UNITED STATES
DEPARTMENT OF THE INTERIOR
BUREAU OF LAND MANAGEMENTHOBBS OGD
MAY 19 2016
RECEIVEDFORM APPROVED
OMB NO. 1004-0135
Expires: July 31, 2010**SUNDRY NOTICES AND REPORTS ON WELLS**
*Do not use this form for proposals to drill or to re-enter an abandoned well. Use form 3160-3 (APD) for such proposals.***SUBMIT IN TRIPLICATE - Other instructions on reverse side.**

Delaware Basin Changes to APD for Federal Well

Summary of Changes to APD Submission

CONDITIONS OF APPROVAL

UH-2 Unihed
Odessa
13" Single Piece

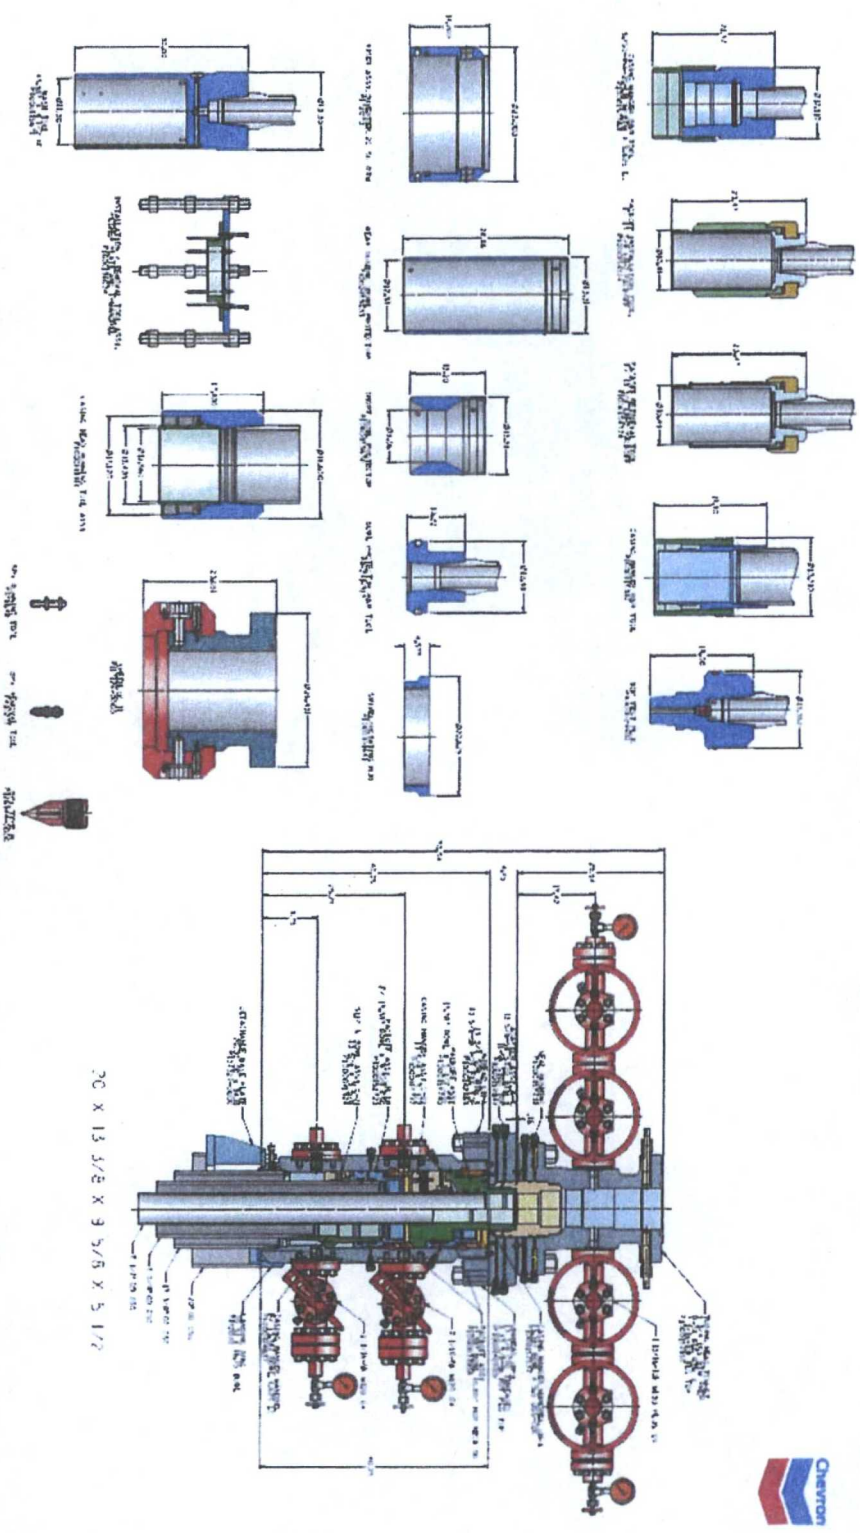
As Defined in APD:	As Planned on Well:
Variance to batch drill not requested.	Chevron respectfully request the ability to batch drill in the SALADO DRAW (14-23) 26 33 PAD (5 TH). The summary provided is a brief description of the main operational sequences for drilling and casing the four wells listed.
Section 3 – Chevron Request a variance to use a GE/Vetco SH-2 Multibowl Well Head	Chevron Request a variance to use a FMC UH2 Multibowl Well Head

3. **Operator has proposed a multi-bowl wellhead assembly. This assembly will only be tested when installed on the surface casing. Minimum working pressure of the blowout preventer (BOP) and related equipment (BOPE) required for drilling below the surface casing shoe shall be 5000 psi.**

- a. Wellhead shall be installed by manufacturer's representatives, submit documentation with subsequent sundry.
- b. If the welding is performed by a third party, the manufacturer's representative shall monitor the temperature to verify that it does not exceed the maximum temperature of the seal.
- c. Manufacturer representative shall install the test plug for the initial BOP test.
- d. Operator shall perform the intermediate casing integrity test to 70% of the casing burst. This will test the multi-bowl seals.
- e. Operator shall perform the 9-5/8" casing integrity tests to 70% of the casing burst. This will test the multi-bowl seals.
- f. If the cement does not circulate and one inch operations would have been possible with a standard wellhead, the well head shall be cut off, cementing operations performed and another wellhead installed.
